Subject: Fwd: SD01 EHS Request - 4/2 Notes

- 14) Im trying to understand the 2015 VI testing. Is it correct that both the June & Dec testing was only a <u>10hr</u> sample? (Pg7) (All previous testing looked like it was 24hr-48hrs in comparison). Based on the previous history of testing results that were above industrial limits, what was the rationale for accepting such a shorter duration of testing?

Fifth Five-Year Review - AMD 901/902 and TRW Superfund Sites and the Offsite OU

Figure B-12. TRW 2014 Soil Excavation and Boring Locations

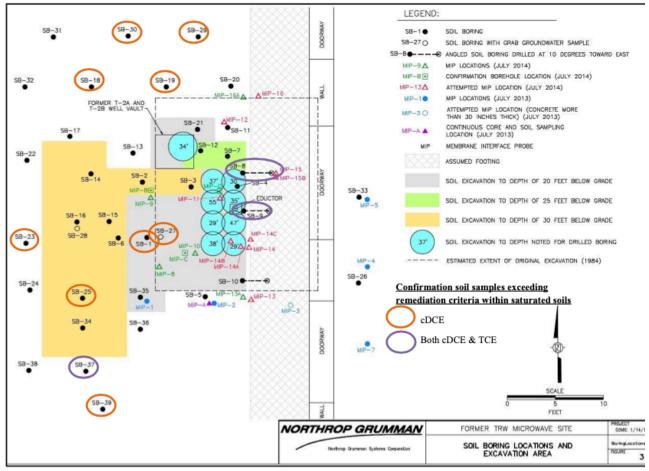
11) per the FYR plan it looks like cDCE (as well as TCE) as found in the soil under the building above remediation criteria. Was there further clean up on it?

(Figure B-12). Confirmation samples collected confirmed the remediation to a depth ranging 25 to 30 feet below ground surface. Twelve of the 39 locations identified in contained concentrations of TCE and/or cis-1,2-DCE above the cleanup levels. Some areas exceeding the cleanup level were not excavated removed due to 1) depth exceeding 25 feet, 2) below groundwater and not feasible to excavate, or 3) in close proximity to the building/building footings. These locations with soil remaining in place that continue to exceed the cleanup level are circled on Figure B-12.
